Bloom Montgomery Village: Preliminary Plan No. 120170150 and Site Plan No. 820170130

Completed: 11/16/17

Description

Figure 4: Initial Preliminary Plan Submission

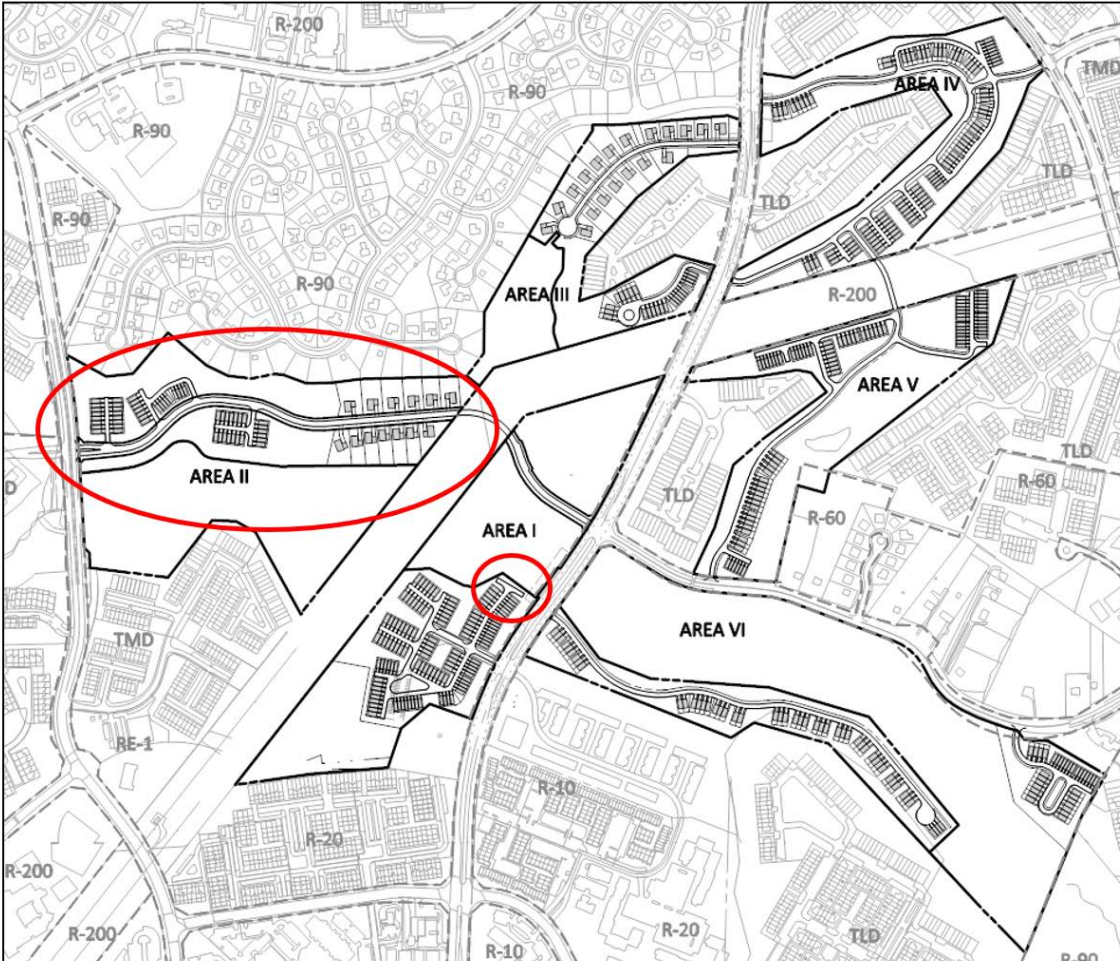
In December 2016, the Applicant submitted a Preliminary Plan that proposed 488 total units including up to 31 detached houses, 455 townhouses, and two duplexes. The Plan proposed dwelling units in the floodplain in Areas 1 and 2, which Staff found unacceptable because the Subdivision Regulations restrict development on unsafe lands within floodplains. In June 2017, the Applicant submitted a Site Plan with a lot configuration substantially similar to the Preliminary Plan showing dwelling units encroaching into the floodplain.

Staff worked with the Applicant to relocate units and to realign proposed Stewartown Road to reduce the impacts to the floodplain and environmental buffers. Thirteen townhouses in the northeast corner of Area 1 were relocated to Area 2, and the townhouses proposed to the south of Stewartown Road in the center of Area 2 were relocated further east, outside of the environmental buffers. The areas that were changed between the initial Preliminary and Site Plan submissions and the revised plans are circled in red in Figure 4.

Figure 15: Proposed and Master Planned Shared-Use Paths on Montgomery Village Avenue and Stewarttown Road

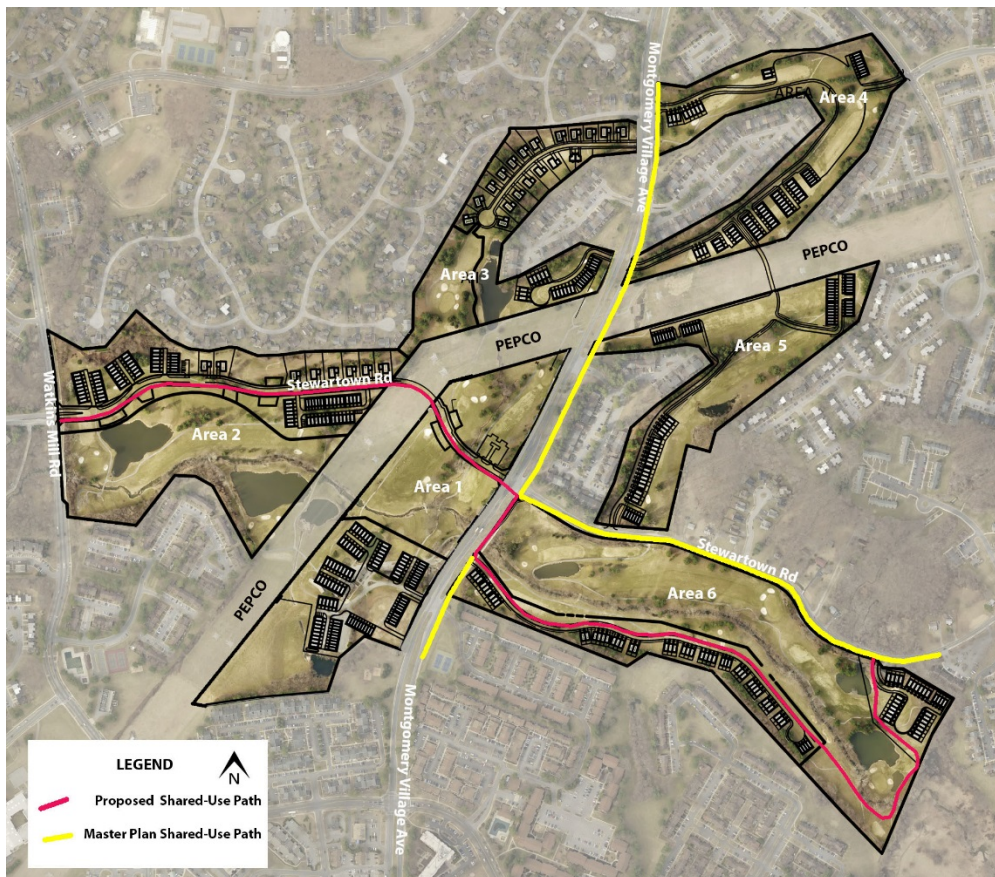
Montgomery Village Avenue is designated as a four-lane arterial road, A-295, with a recommended 100-foot-wide right-of-way between Midcounty Highway and Wightman Road. The existing right-of-way is

100 feet wide with sidewalks along both sides. The Master Plan recommends a shared-use path, LB-1, on the east side of Montgomery Village Avenue between Wightman Road and Lost Knife Road to tie into the existing shared-use path built on the east side of the road along Lake Whetstone. The Applicant is not proposing to build this shared-use path because they would have to rely on the adjacent HOAs to provide the extra right-of-way needed to build a continuous path. According to the Applicant, the HOAs are not willing to work with the Applicant to implement this upgrade. Due to the gaps (existing HOA-owned lands) in Property frontage along Montgomery Village Avenue, requiring the Applicant to install a fragmented shared-use path along this portion of Montgomery Village Avenue is not the best option. Lack of needed right-of-way, steep slopes, and other environmental constraints would result in a patchwork of new shared-use path and existing sidewalk. The existing 100-foot right-of-way is wide enough to accommodate a shared use path on each side of the road as a comprehensive redesign of the entire stretch of Montgomery Village Avenue as part of a future CIP project. Therefore, Staff recommends that the shared-use path along Montgomery Village Avenue be installed within the existing 100-foot right-of-way as part of a future comprehensive road construction project.

- f. Add the master-planned shared use path along the south side of Stewartown Road, separated from the road by a four-foot wide green panel, between Montgomery Village Avenue and Private Road “J” in Area 6. The shared use path should be ten-feet wide where possible, but it must be a minimum of eight-feet wide in environmentally constrained areas.
